Tuesday July 29 2025
Addendum #2

23042 Wake County Marbles Boiler Replacement
Wake County
RFB #25-072

M401

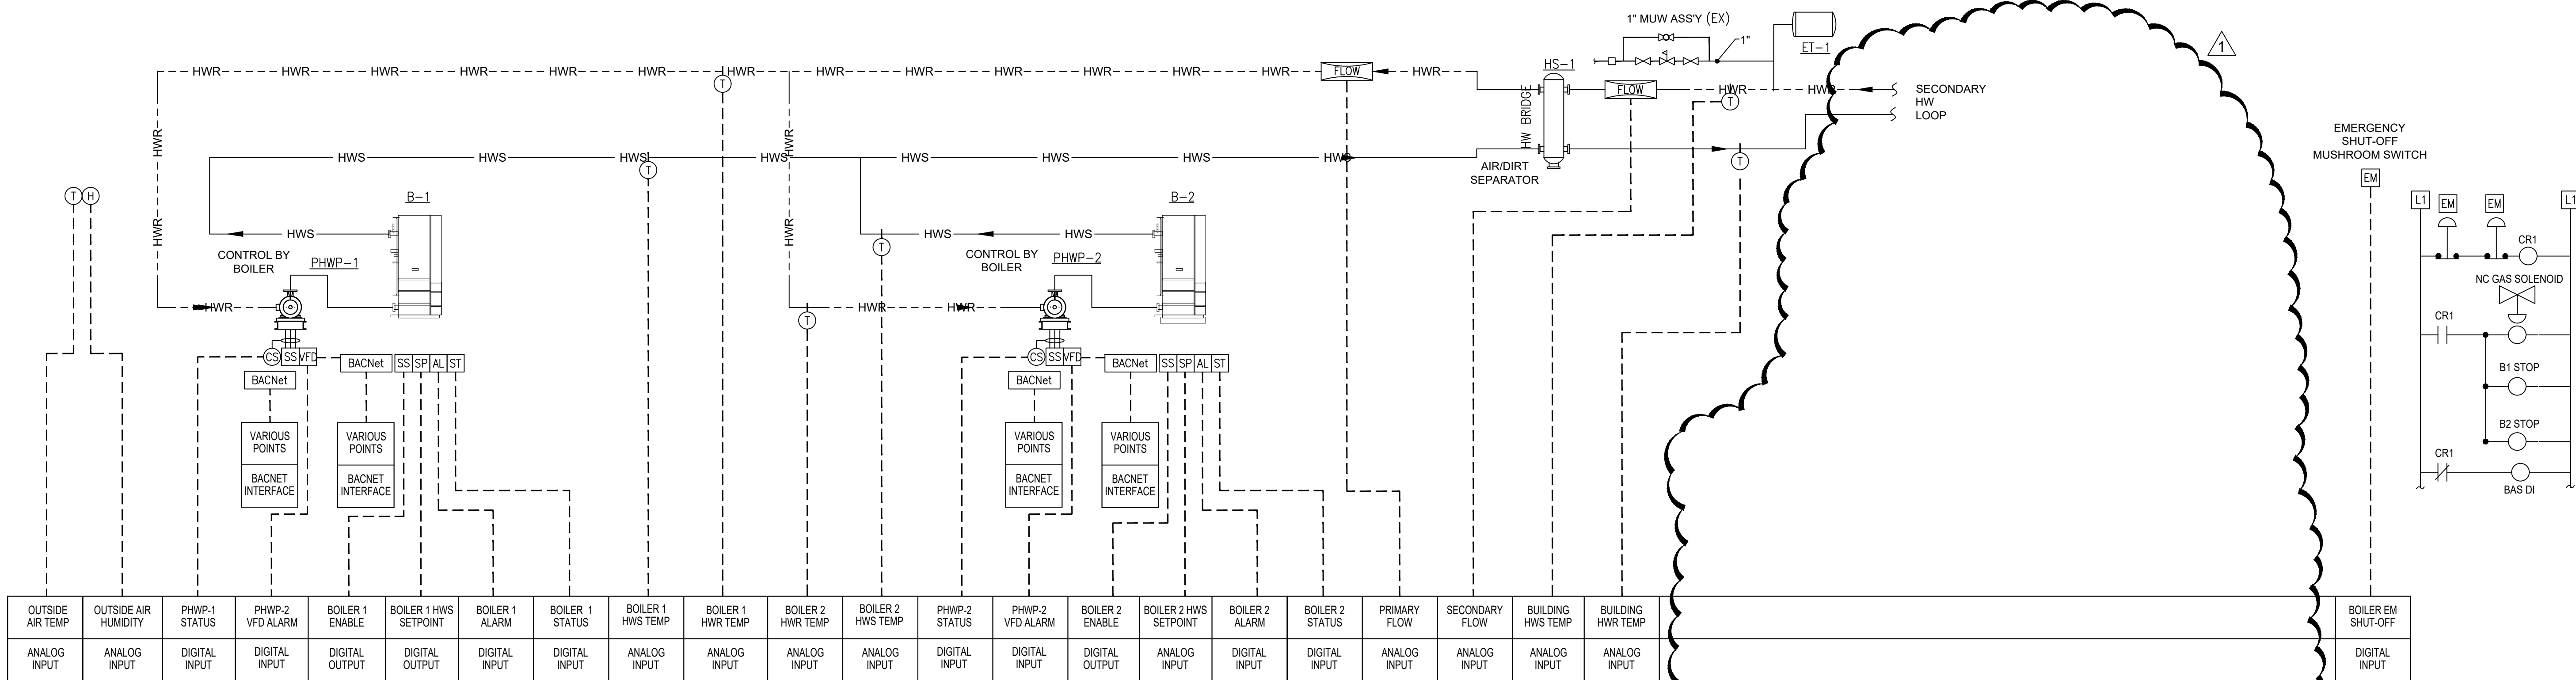
- a) M401 revised to reduce secondary HW controls work. Refer to attached.
